**SERVICE BULLETIN**

**APPLICABILITY:** 2017-20MY Impreza  
2018-20MY Crosstrek

**NUMBER:** 12-283-20

**SUBJECT:** Hood Stay Support / Prop Rod- Design Change

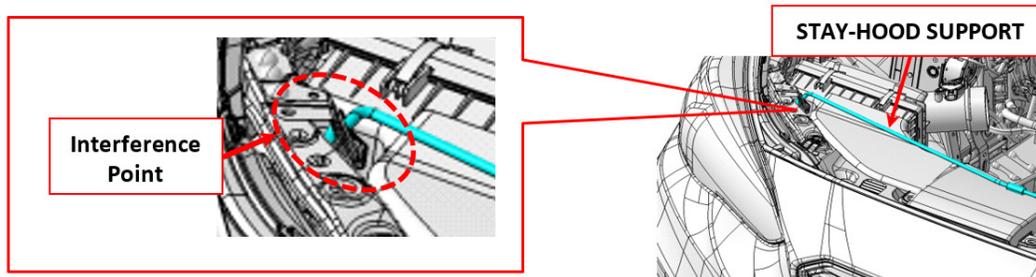
This bulletin announces a design change made to the hood stay support (a.k.a. prop rod). The change prevents a vibration sound resulting from contact with adjacent under-hood components.

A section of cushion was added as shown below to eliminate the source of the vibration sound.

The part number for the new stay support is: **57251FL001**.
